Subject: Change Oder 005- Midway Branch Force Main Conflicts and other Scope Modifications

Change Order 005-Midway Branch Force Main Delays

Change Order No. 05
Corporate Dr Segments 4&5
Project No. G1124 &G1125

HOLFORDS UTILITY IMPACTS

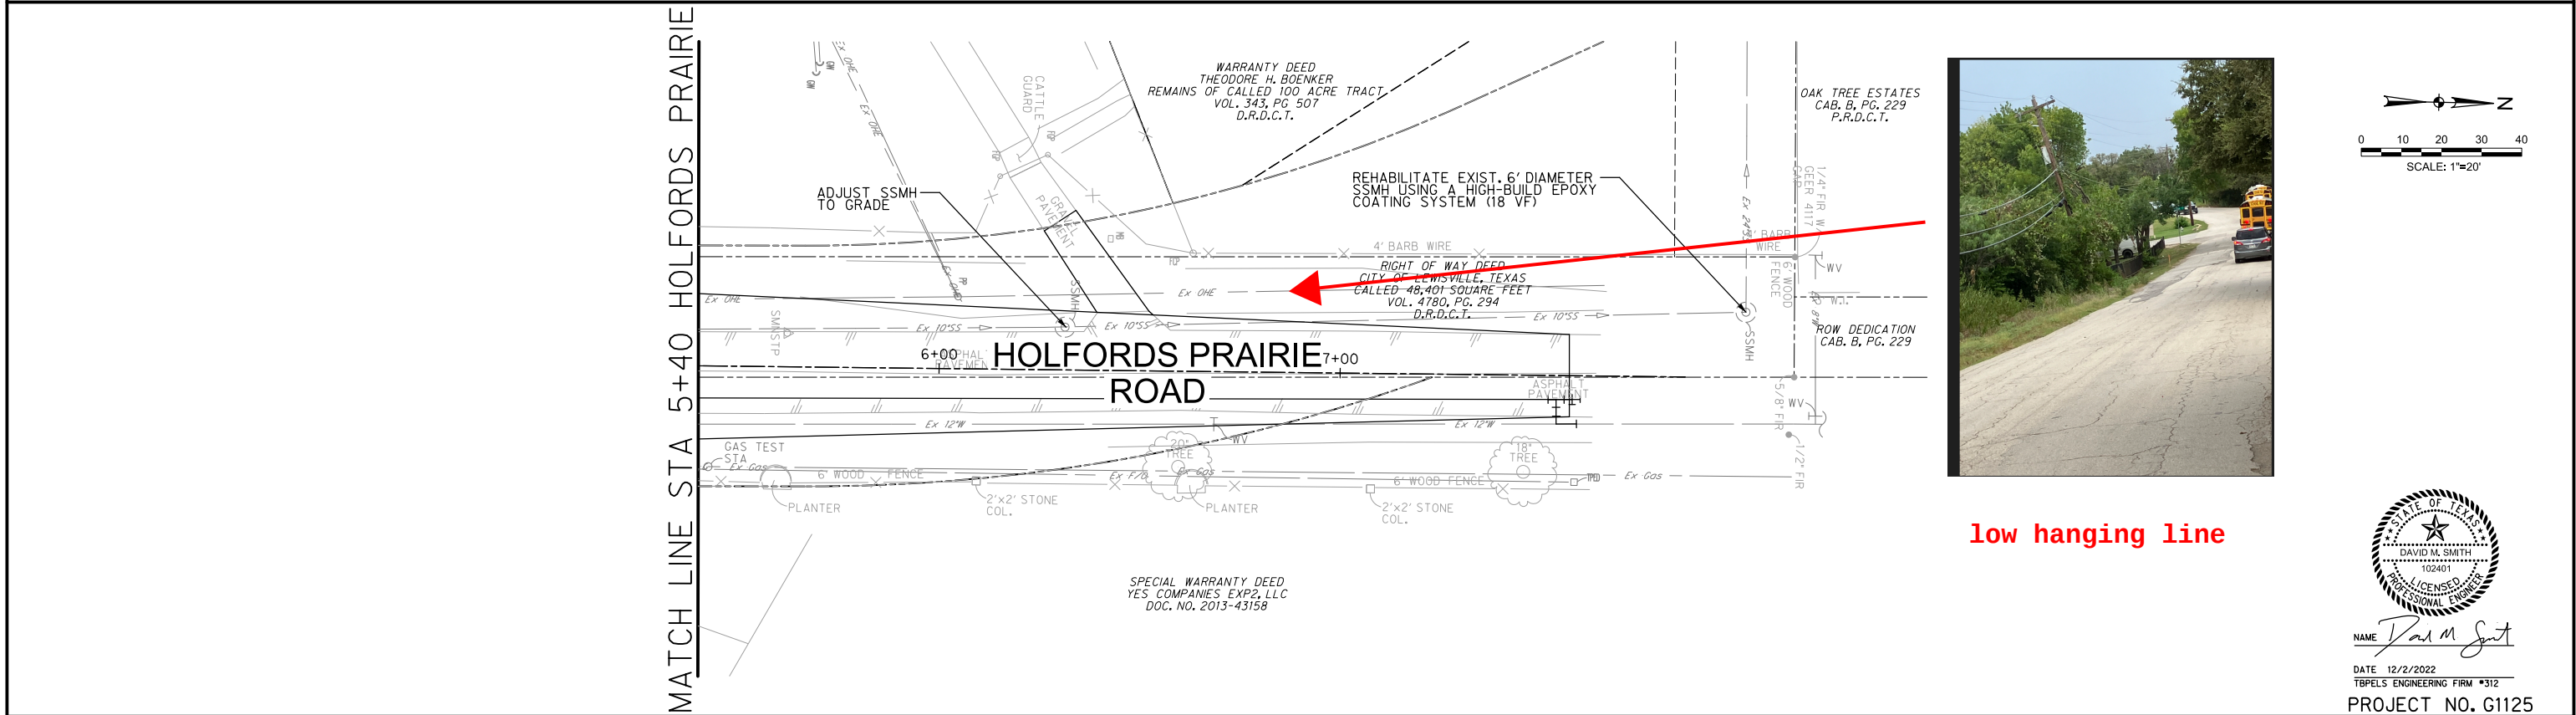
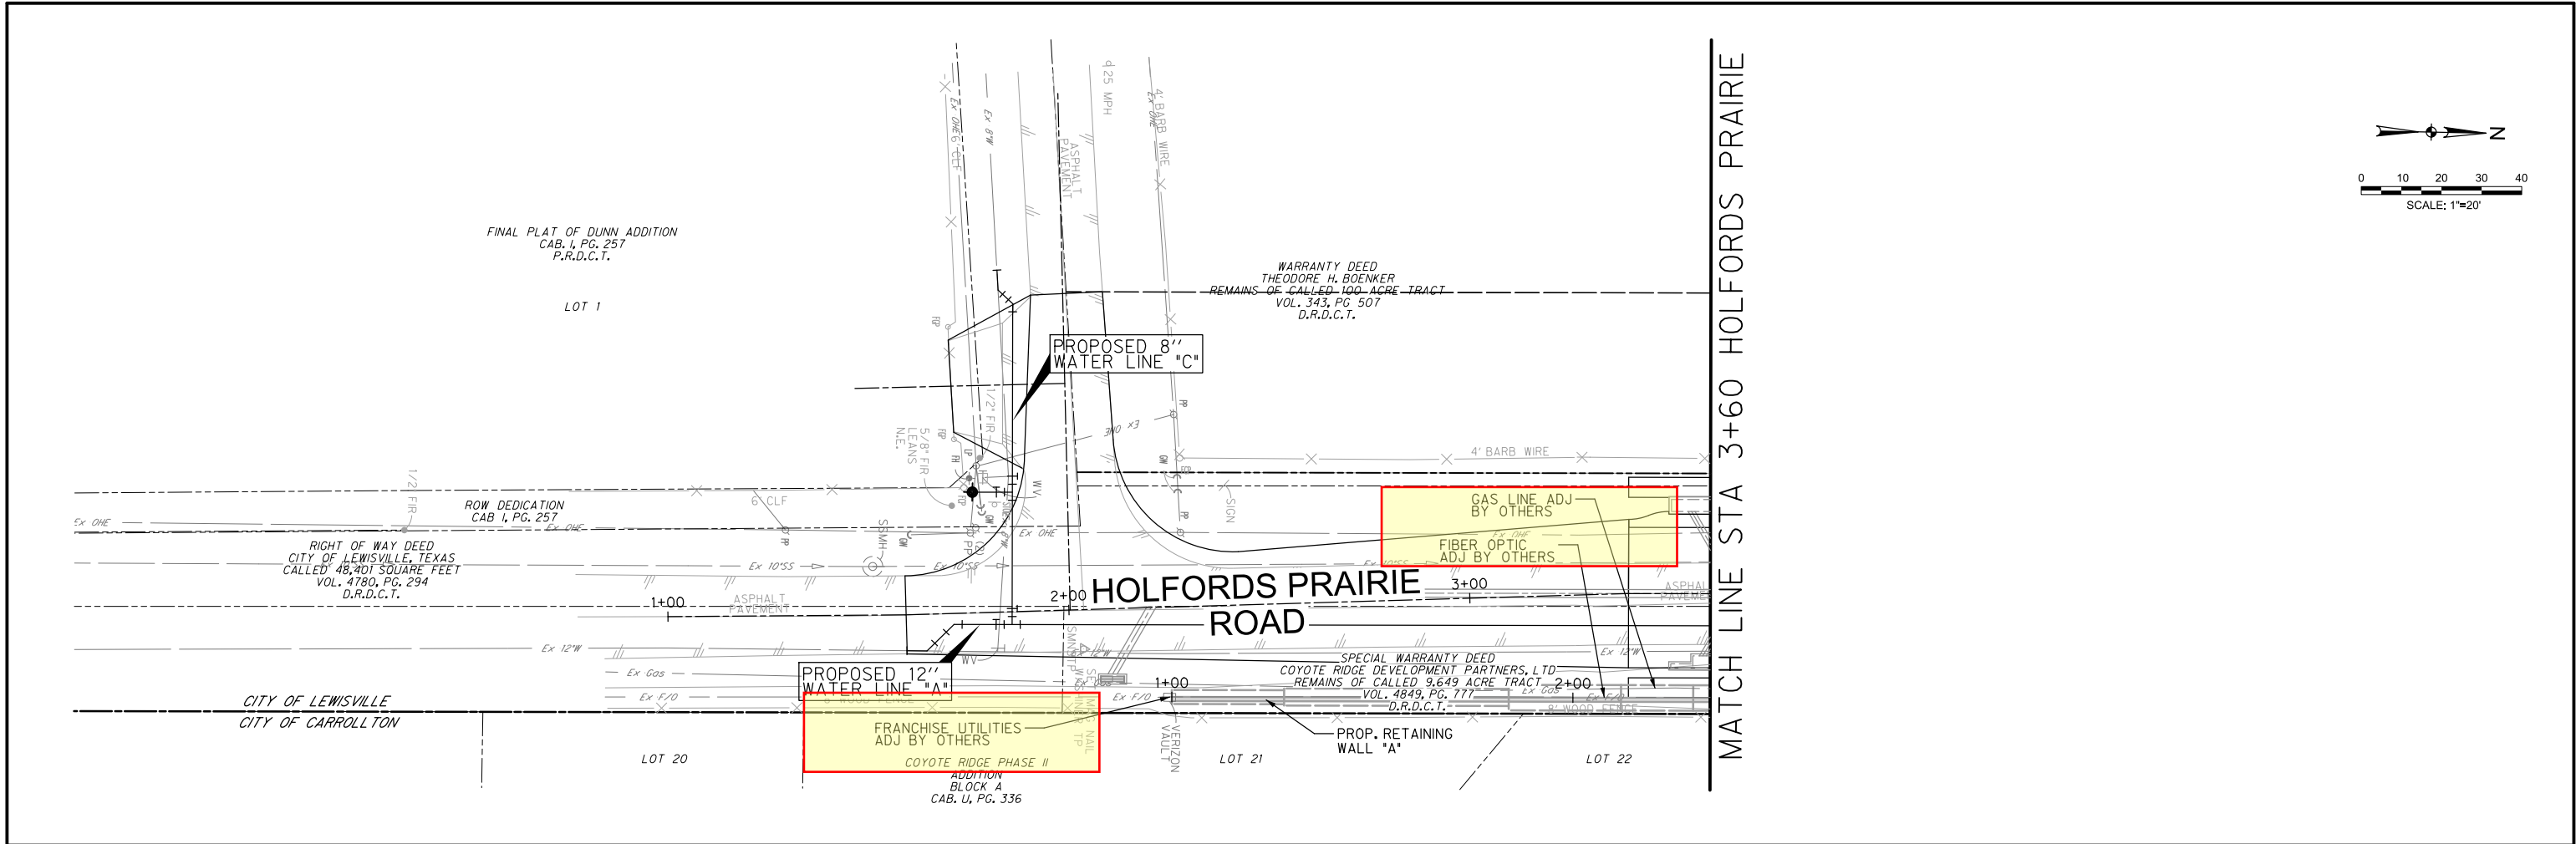
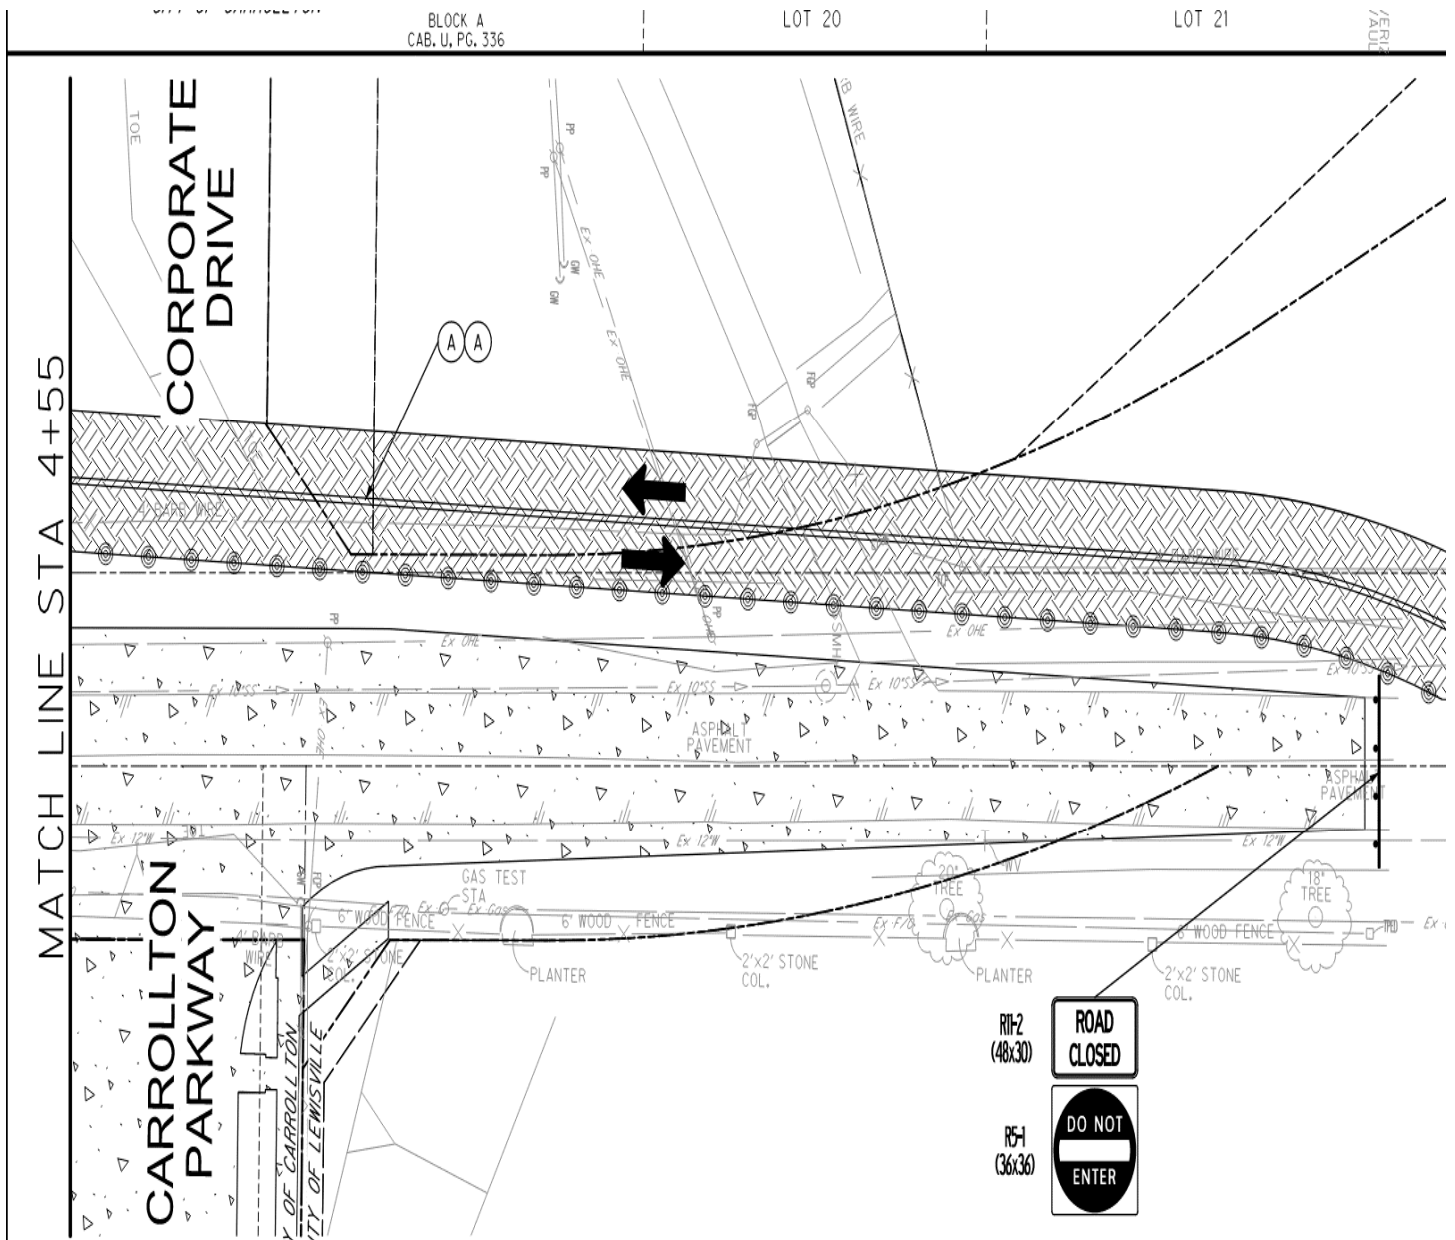
low hanging line

We will not be able to switch traffic on Holfords Prairie due the leaning pole and the low hanging communication line. The survey stake in the picture is the start of the detour on the north side of the road. We can discuss further in the coordination meeting.
